Kogarah Golf Club Redevelopment Concept & Stage 1 works

5 July 2026

BIKEast Incorporated
www.bikeast.org.au

BIKEast is pleased to make a submission on the [Kogarah Golf Club Redevelopment Concept & Stage 1 works](#).

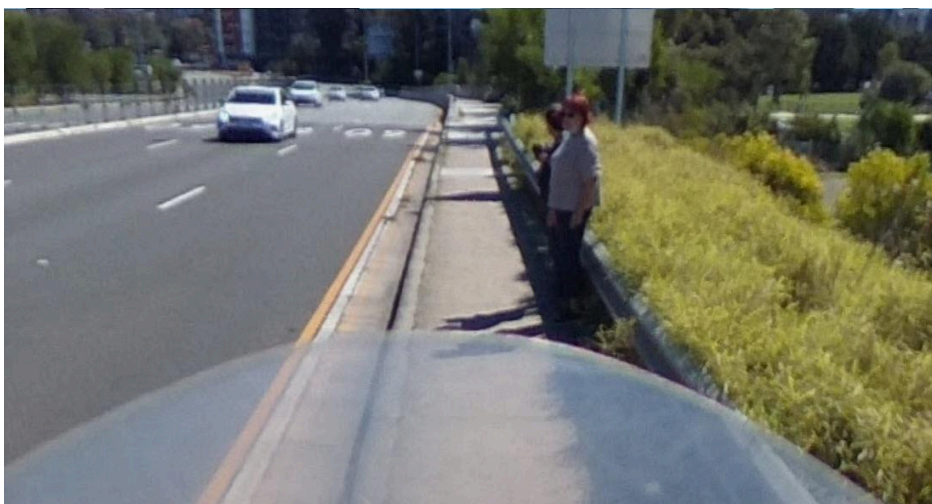
Current diagram in Appendix V - Transport Impact Assessment does not accurately show the missing links across Giovanni Brunetti bridge.

The current path is not shared path and risks injury with the nearby lane speed limit at 60km/h -

Current width of Marsh St's direct route across Giovanni Brunetti bridge is unsafe

The footpath width is unsafe for two way pedestrian access, let alone walking and cycling.

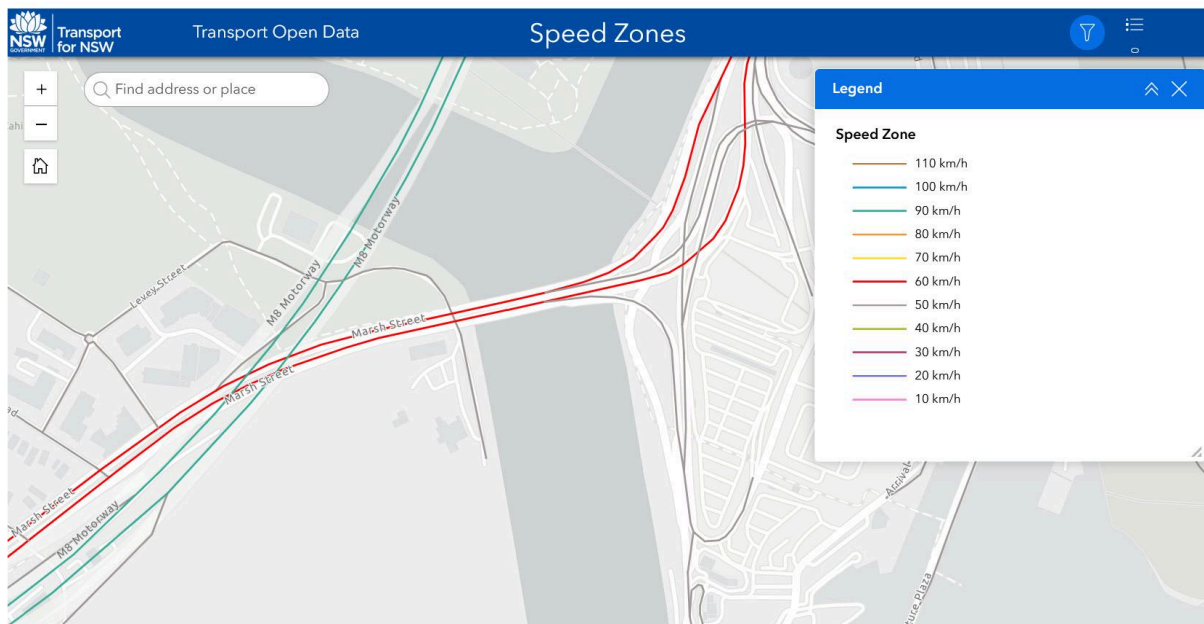
Current safe detour is 1.5km longer than direct route.

Direct route 0.38km

Current detour to avoid risk of falling on road - 2.04km

Figure 21 Existing cycling infrastructure

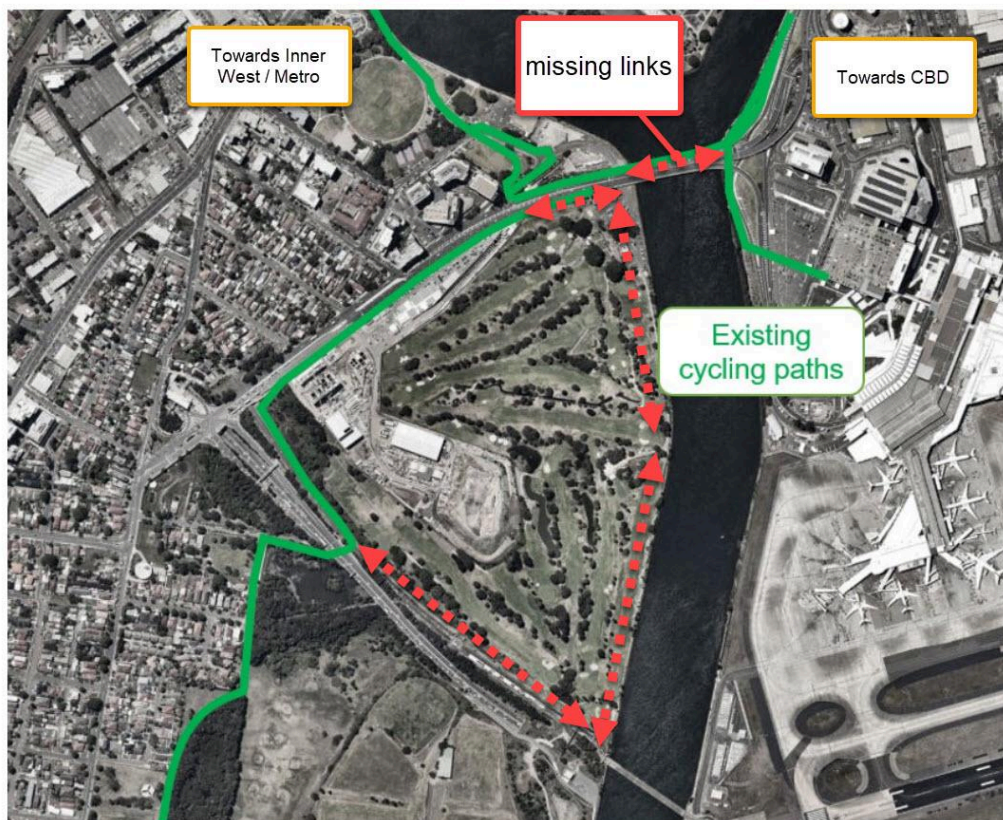
Missing links (identified below) must be built to enable safe movement

Missing connection in Kogarah Gold Club project area.

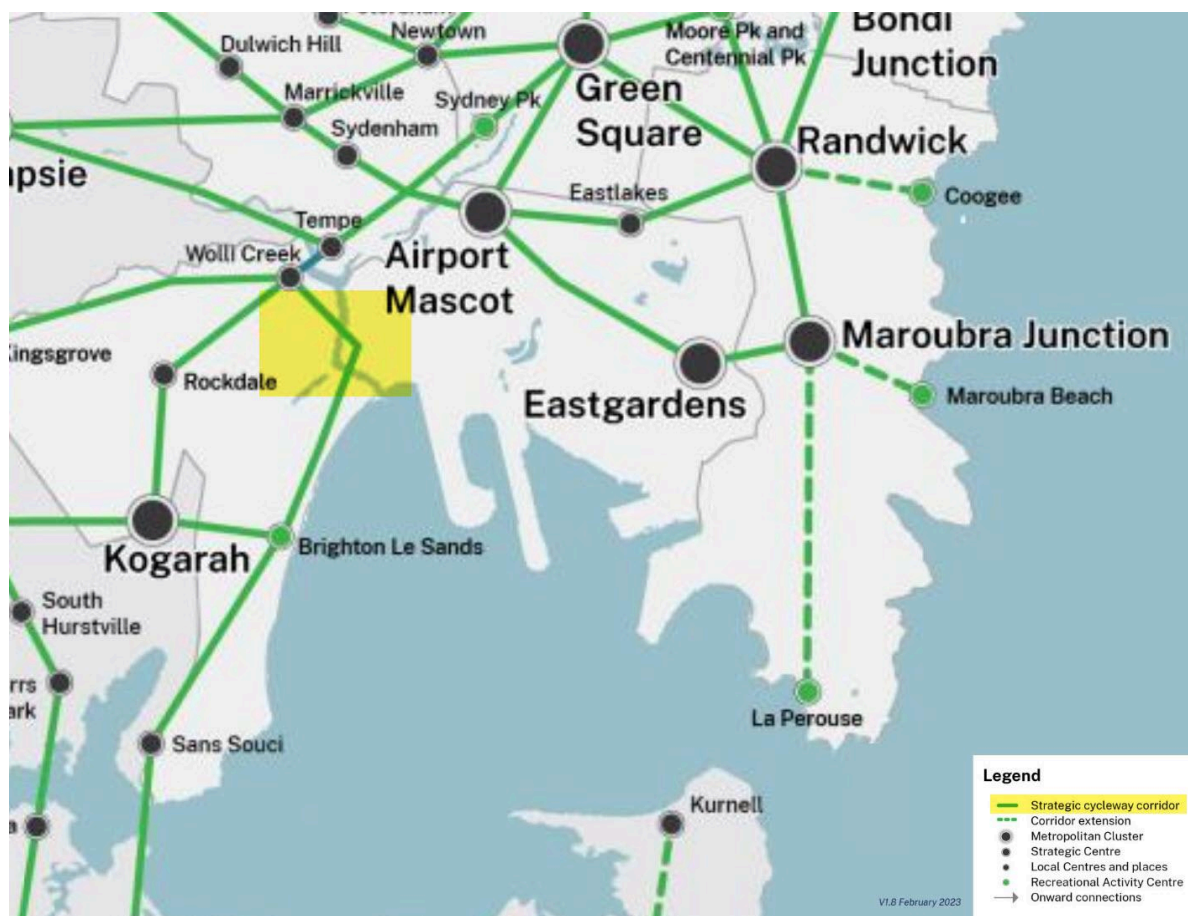
3. NSW Government must fulfil the requirements of delivering the strategic cycleway corridor section from Wolli Creek to Brighton Le Sands.
